Illinois Department of Transportation

Memorandum

To: ALL BRIDGE DESIGNERS 19.3
From: D. Carl Puzey *D. Carl Puzey*
Subject: Revised provisions for Precast Prestressed Concrete IL
Beams and applicable I and Bulb T Beams
Date: March 25, 2019

**IL72-2438 SIMPLE SPAN LIMITS
(Strand Pattern/Span Length/Beam Spacing)**

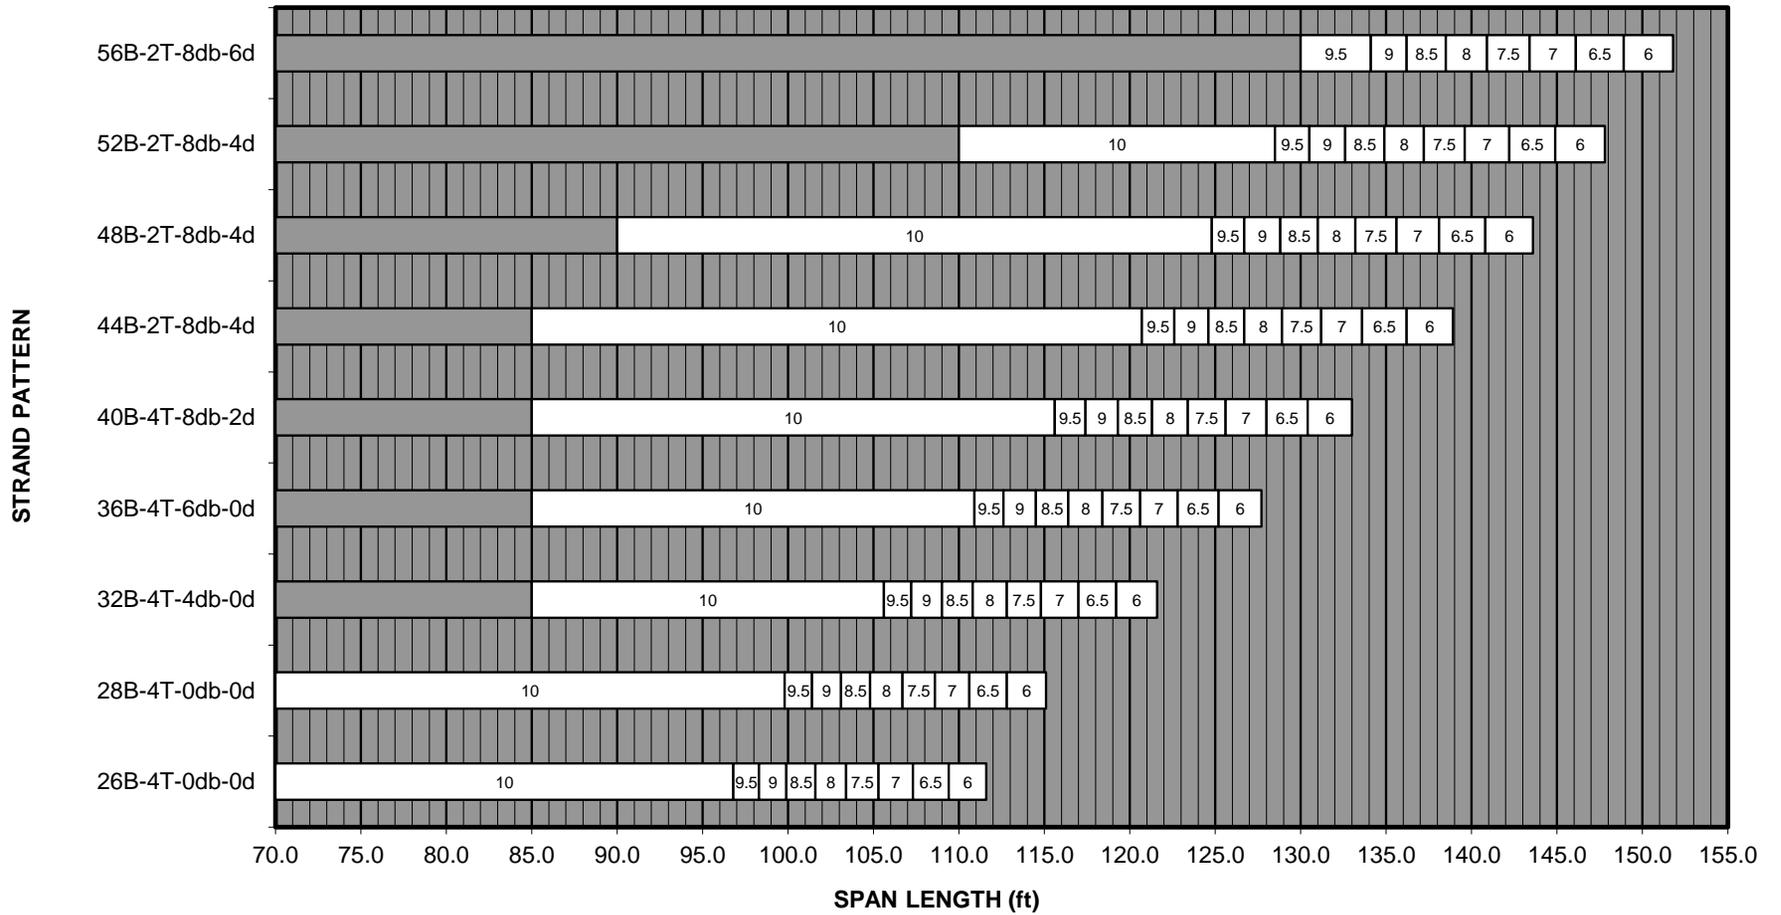
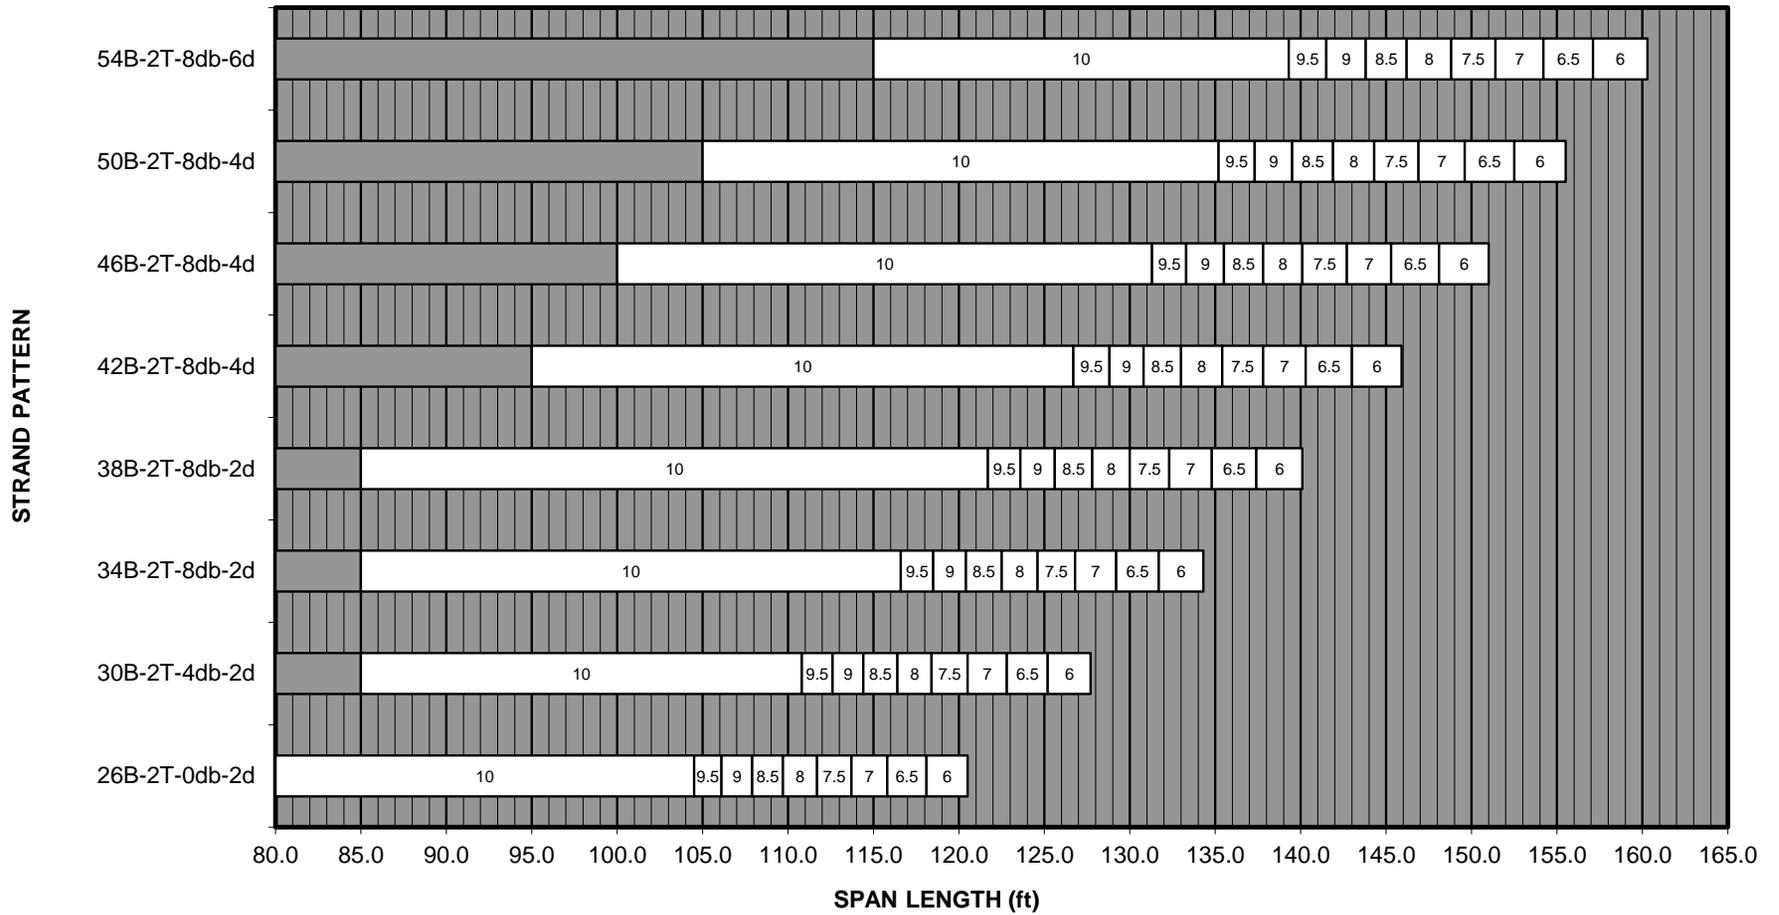
The Department evaluated our standard strand patterns and beam configurations for an f'_c of 6.5 ksi and found that the allowable span length for each beam depth would be reduced by an amount less than two feet. Therefore, the IL-Beam base

sheets have been updated to allow a concrete release strength of 6.5 ksi instead of 7.0 ksi and the Planning Charts, Figures 4 through 16 of ABD memorandum 15.2, have been updated with slightly reduced permissible span lengths. These charts are included in this memorandum.
